MINUTES
BROOKSHIRE-KATY DRAINAGE DISTRICT

August 14, 2023

Reference: Cardiff Road Partners, LP
Cardiff Business Park Proposed Office Warehouse Paving & Drainage to Serve Proposed Lot 2
– **Final Drainage Plans**
Permit No. 2023-18
Quiddity, Inc. Job No. R0002-1003-75

Figure 3: Atlas 14 100-Year Flow and Stage Hydrographs of Cane Island Branch Immediately D/S of Clay Road

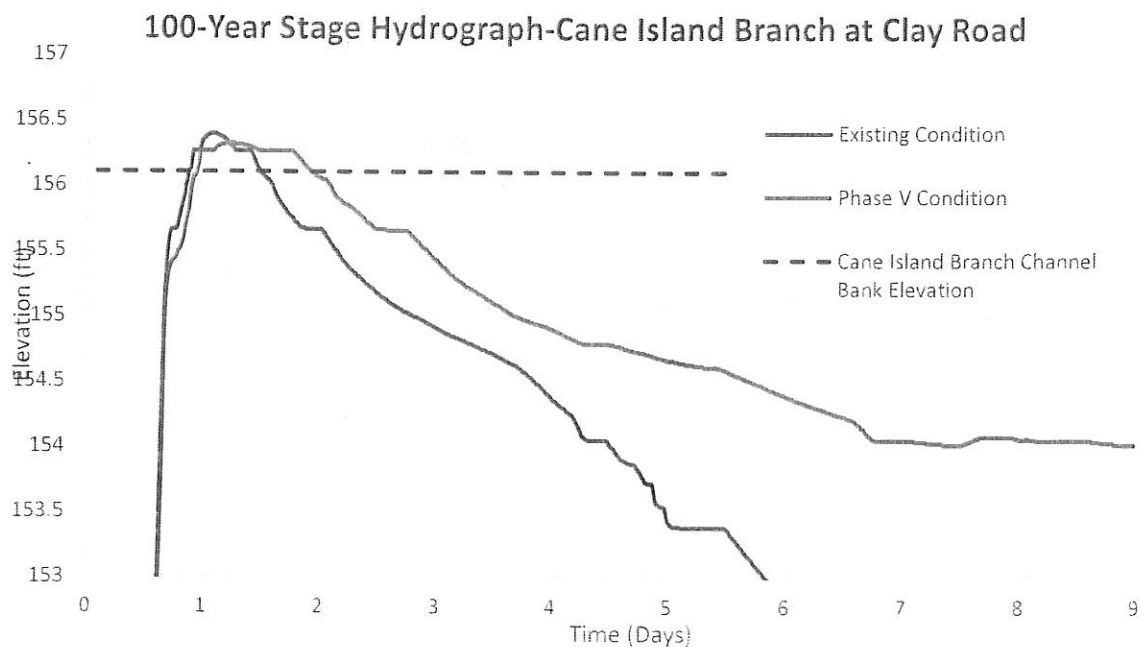
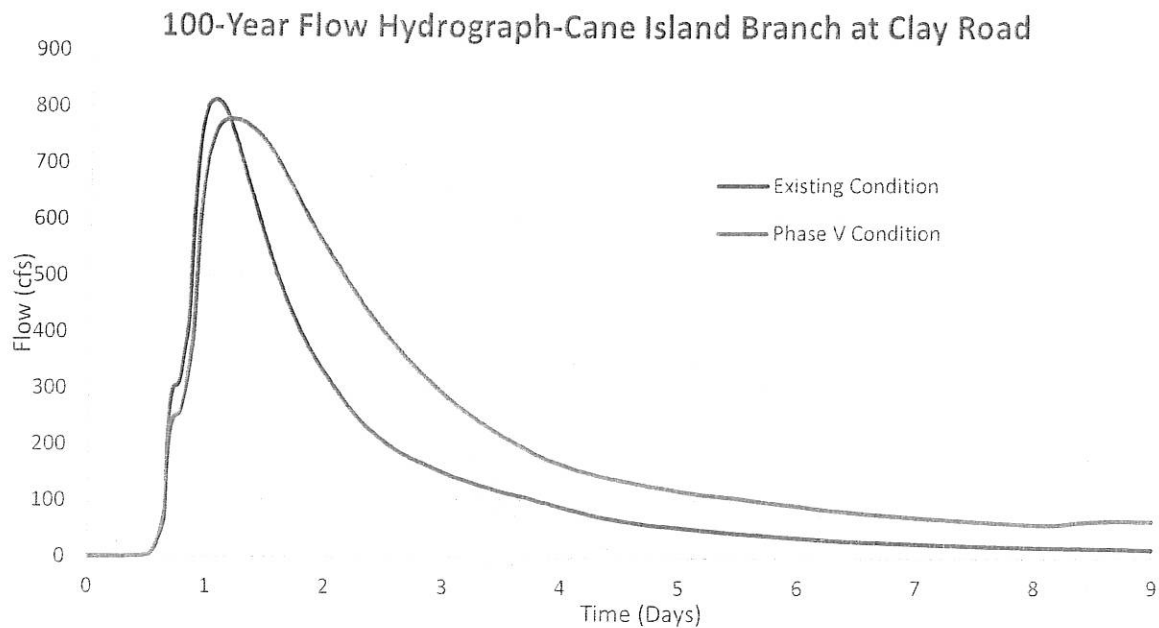
4. **Report Tables and Figures:** Peak flows and WSE do not appear to match CIB-7 from Table 6 for the Atlas 14 100-yr condition. Please provide reasoning.

Quiddity Response: The peak flows listed in Table 6 were taken from the old effective steady state model while the peak flows in Figure 3 are from the models included in this submittal. Because this is not a good comparison the peak flow comparison has been removed from Table 6.
